PLANNING & ZONING COMMISSION

CASE NO: PZ 16-10

REQUEST: HOLD A PUBLIC HEARING AND FORWARD A RECOMMENDATION TO THE CITY COUNCIL

High Point Vista Memory Care Facility For Petersen Health Care 6413 N MT HAWLEY RD, PEORIA, IL 61614 DKA PROJECT NO: 15 - 027

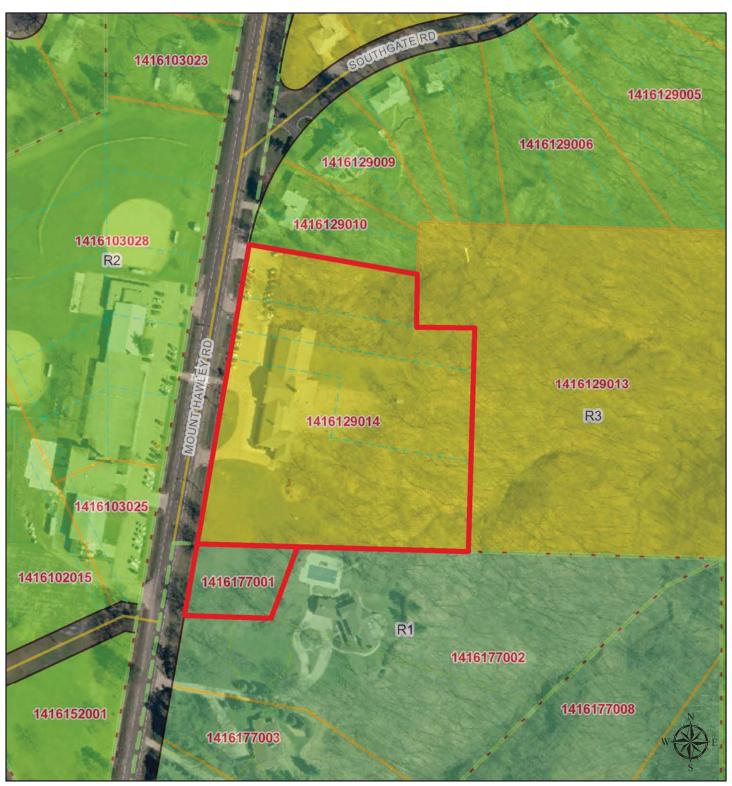
- 1. Waiver to allow the existing parking area to remain within the required front yard setback.
- 2. Waiver to increase the height of the retaining wall from 3 feet to 7.3 feet

- 3. If a waiver is granted to allow 6 additional parking spaces in the front yard, a fee for overparking, in the amount of \$1,750, is required and must be paid before any permits are issued.

- 4. All rooftop and ground level mechanical equipment and utilities must be screened per Zoning Ordinance requirements.
- 5. One additional shade tree must be added to the site plan to meet the parking lot landscape requirement; a revised landscape plan is required.

- 7. A revised landscape plan should be provided before permits are issued showing additional landscaping in the TBY along the north property line, within the first 70 linear feet, to create a substantially solid visual barrier.

- 9. A revised site plan must be provided reflecting the required setback of 12.5 feet for the proposed monument sign and a building permit is required for the proposed sign.
